ROAM
ARCHITECTURE

Re: ZBA drawing Revision for:
168 Washington Street, Tappan, N.Y.

The revisions to drawings include:

New M. Bathroom Addition For:
MESIBOV RESIDENCE
168 WASHINGTON STREET
TAPPAN, N.Y. 10983

GENERAL NOTES, DETAILS,
ZONING INFORMATION &
DESIGN CRITERIA

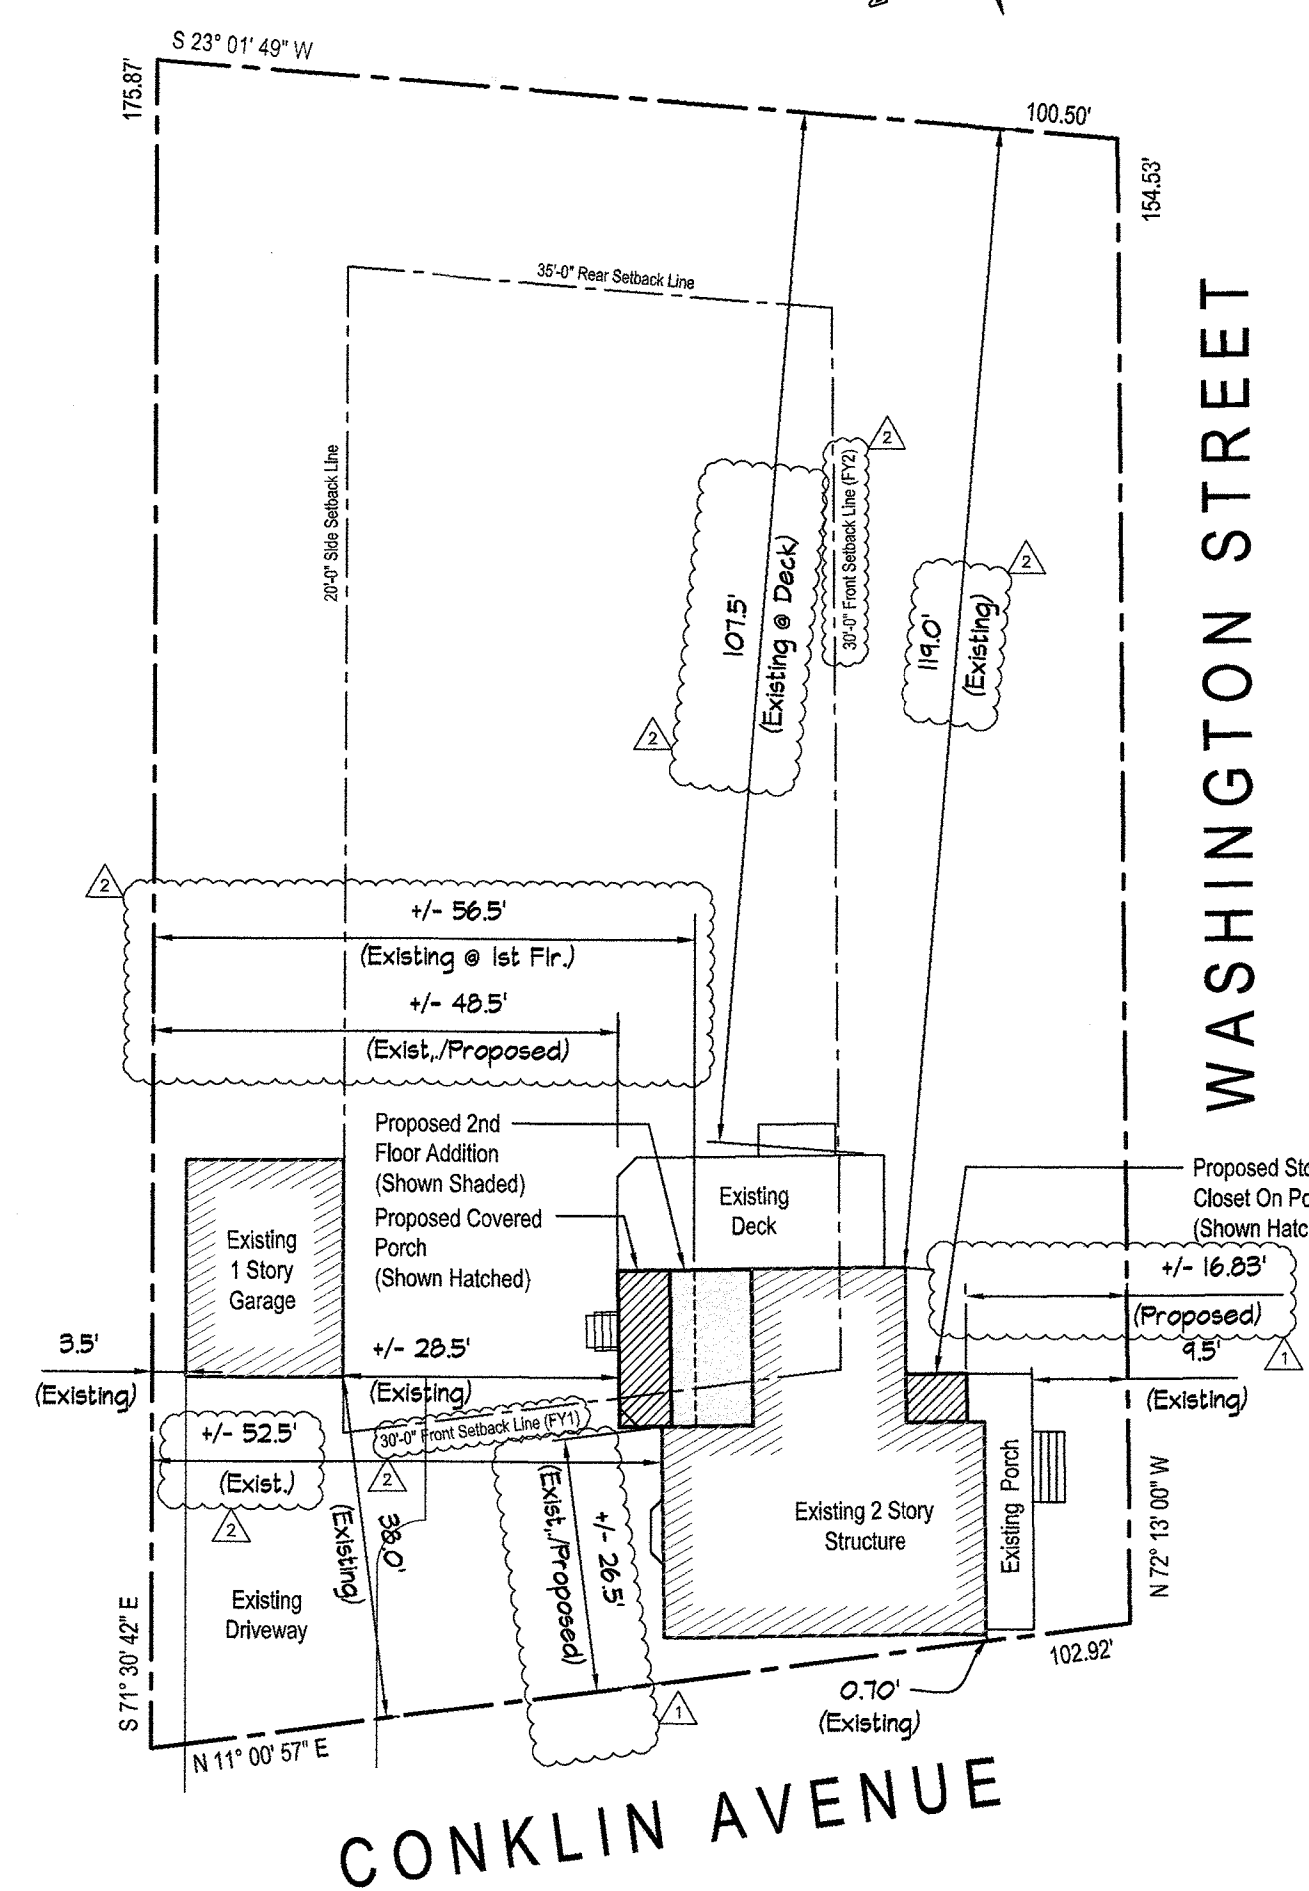
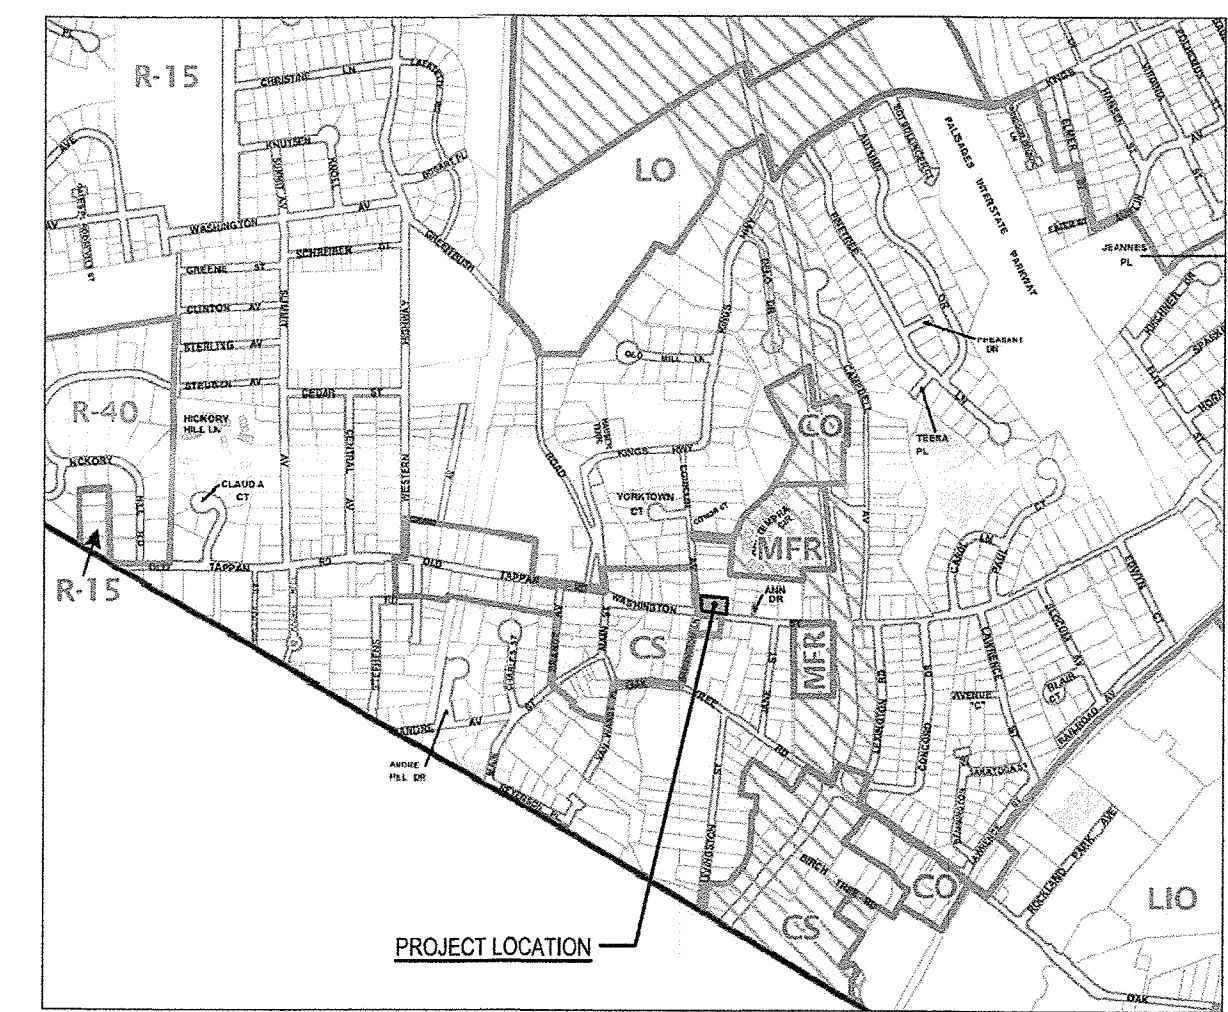
- On Sheet A-0, the Table of Bulk Regulations has been updated as follows per ZBA request:
 - Proposed FAR was revised as follows:

ITEM	PROJECT DRAWING DATED 6-20-24 Revision #1 - 9-19-24	RESUBMITTED DRAWING DATED Revision #2- 12-11-24	NOTES
House Size (existing)	2,649 SF	2,665 SF	Main house + garage
House Size (with proposed addition)	2,649 + 264 SF = 2,913 SF	2,665 + 264 SF = 2,929 SF	Increased due to increased existing house size (above)
Lot Size	16,709 SF	No Change	
Existing FAR	0.159 (15.9%)	No Change	
Proposed FAR	0.174 (17.4%)	0.175 (17.5%)

- Proposed Setbacks have been clarified as follows:

ITEM	EXISTING	PROPOSED ADDITION	NOTES
Front Yard Setback #1 (FY1) - Conklin Avenue	0.70 feet (existing non-conforming)	26.50 feet (at proposed covered porch)	Variance Required
Front Yard Setback #2 (FY2) – Washington Street	9.5 feet (existing non-conforming)	16.83 feet (at proposed closet)	Variance Required
Side Yard (SY) Setback	+/- 48.5 feet (to deck)	No change	
Rear Yard (RY) Setback	+/- 107.5 feet (to deck)	No change

- The setback locations given above have been revised to correspond to the updated official designation of the front of house. (Conklin Ave.)
- The above existing non-conforming values in the front yard setbacks (FY1 and FY2) of the existing home have not changed.
- Values under “proposed addition” are for the proposed new construction.

CATEGORY	REQUIRED / ALLOWED	EXISTING	PROPOSED ADDITION	COMMENTS
MINIMUM LOT AREA	15,000 SQ. FT.	16,709 SQ.FT.	NO CHANGE	
MINIMUM LOT WIDTH	100 FEET	100.50 FEET	NO CHANGE	
MAXIMUM FLOOR AREA RATIO	0.20 (20%)	0.159 (15.9%)	0.175 (17.5%)	
FRONT YARD SETBACK FY1 - CONKLIN AVENUE	30 FEET MINIMUM	0.70 FEET EXISTING NON-CONFORMING	± 26.50 FEET (At Porch)	** Variance Required
FRONT YARD SETBACK FY2 - WASHINGTON ST.	30 FEET MINIMUM	9.5 FEET EXISTING NON-CONFORMING	± 16.83 FEET (At Closet)	** Variance Required
SIDE YARD SETBACK	20 FEET MINIMUM	N/A	(+/- 48.5 FEET @ DECK)	
TOTAL SIDE YARD SETBACK	50 FEET MINIMUM	N/A	N/A	
REAR YARD SETBACK	35 FEET MINIMUM	N/A	(107.5 FEET @ DECK)	
BUILDING HEIGHT	12" PER FOOT (35 FEET MAX.)	N/A	(+/- 23.33 FEET)

Existing:
 Detached Garage: 371 Sq.Ft.
 Cellar: 0 Sq.Ft. *
 First Floor: 1,010 Sq.Ft.
 Second Floor: 1,284 Sq.Ft.
 Total: 2,665 Sq.Ft.

2,665 / 16,709 = 0.159 (15.9%) *

Proposed:
 Basement: 0 Sq.Ft. *
 First Floor: 130 Sq.Ft.
 Second Floor: 134 Sq.Ft.
 Total: 264 Sq.Ft.

2,665 + 264 = 2,929 / 16,709 = 0.175 (17.5%) *
